## SERVICEORDRE – 2005-01

- HENVISNING:** Mirage Systems Product Service Bulletin 12-04 (vedlagt).
- FORMÅL:** Flytte kutter for nødåpner (Cypres og Astra) fra under reservepakksekks lukkeklaff 1 til under lukkeklaff 3.

## PRODUCT SERVICE BULLETIN 12-04

**SUBJECT:** AAD CUTTER LOCATION CHANGE

Step 6.

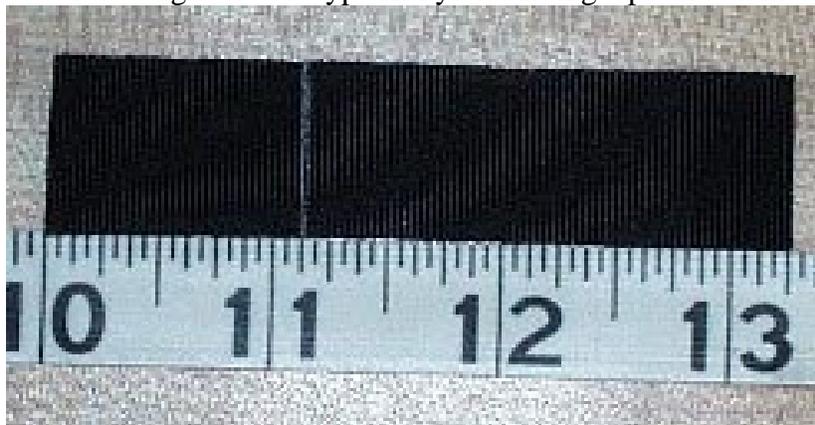
Lay the template against binding tape and grommet. Mark **three** locations as shown.

- a. With snips or seam ripper, carefully cut the L shape that connect the dots through the Para pack layer only. Lightly sear the cut Para pack edge with a hot knife or lighter.
- b. If the center flap has this row of stitching running below the grommet, a short section may need to be removed.

Step 8.

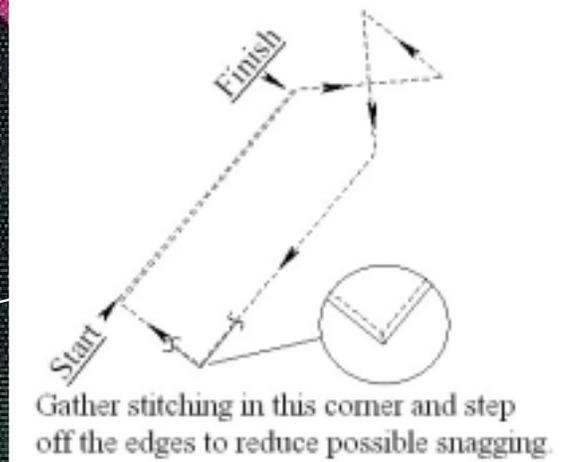
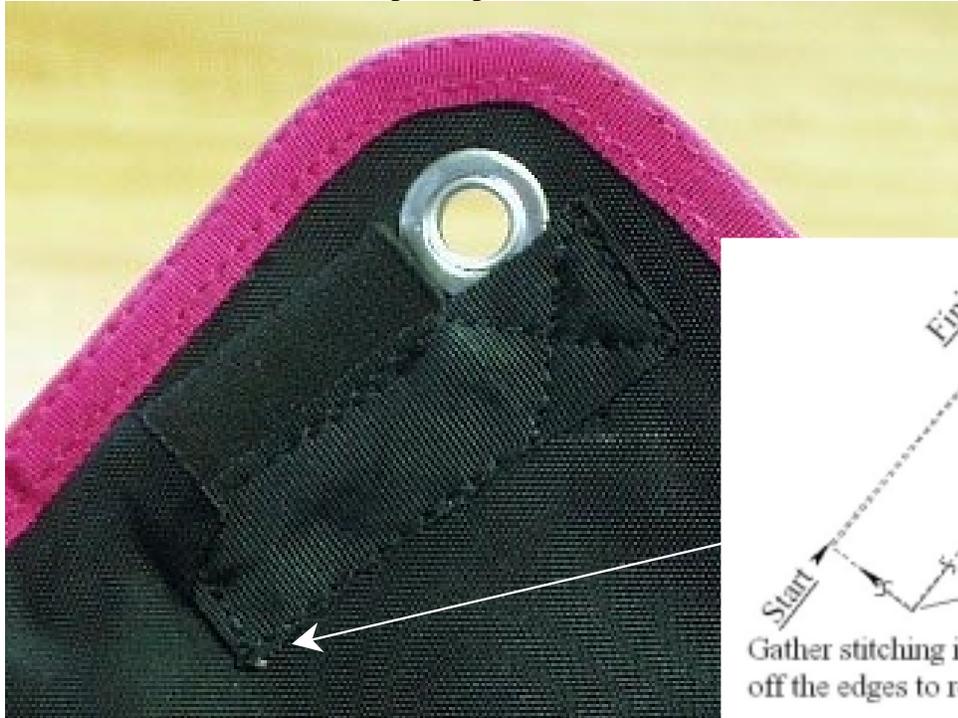
- a. Hot cut a 3 1/4" length of 3/4" type III nylon binding tape and mark at 1 1/8".

b. The elastic cutter keeper setup may be pre-sewn as shown here or glued as follows.

c. With a crafts hot glue gun, run a thin bead across the binding of the elastic keeper and firmly lay type III binding tape in place.

d. Fold short end over and lightly hot glue back side into place.

Step 10.

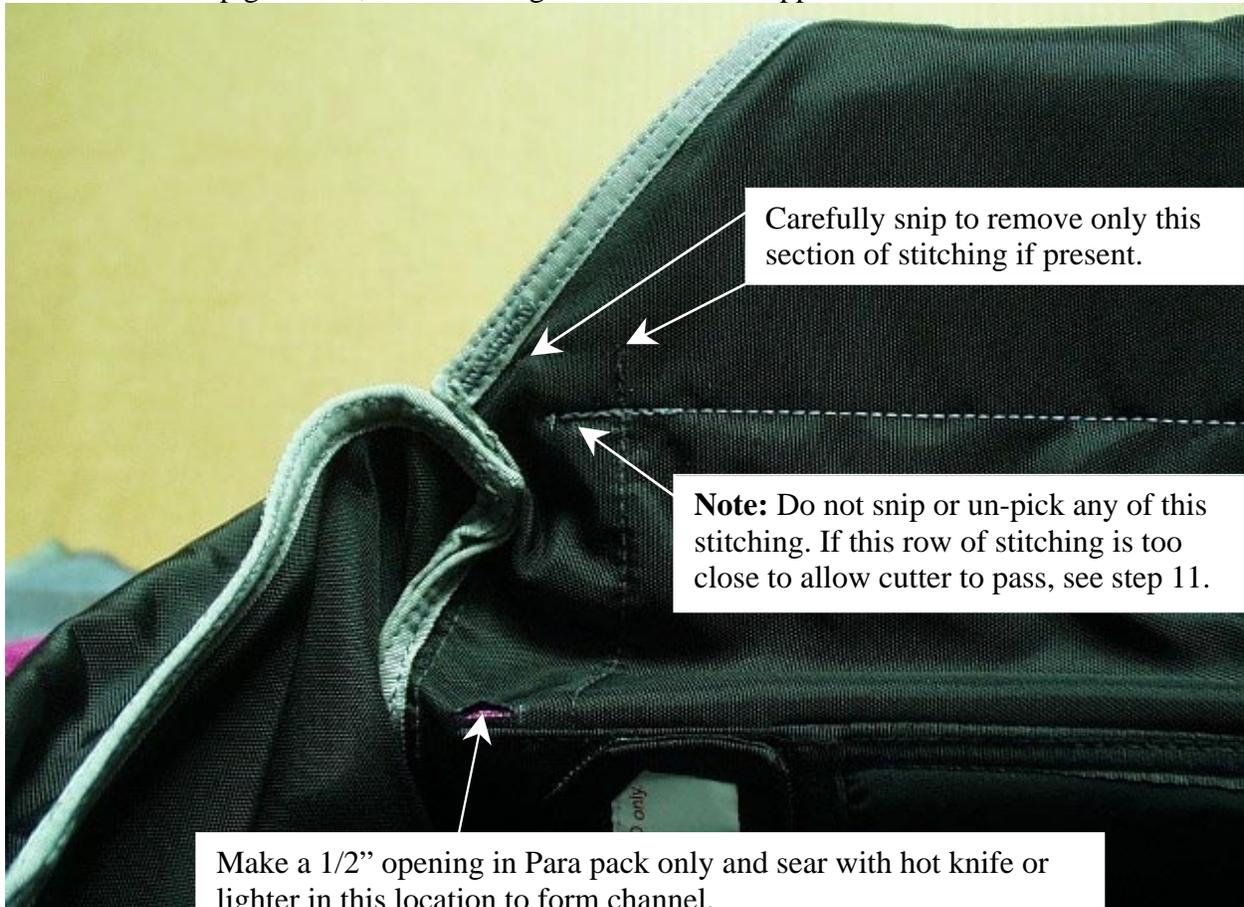
In order to open a channel for the cutter cable to pass from to processing unit to the #3 center flap grommet, the following measures must happen.

Only if the center flap row of stitching is too close to the corner to allow the cutter to pass, 2 additional 1/2" openings will need to be made around this stitch pattern and carefully seared with a hot knife or lighter. This will allow the cutter cable to bridge this stitch pattern.
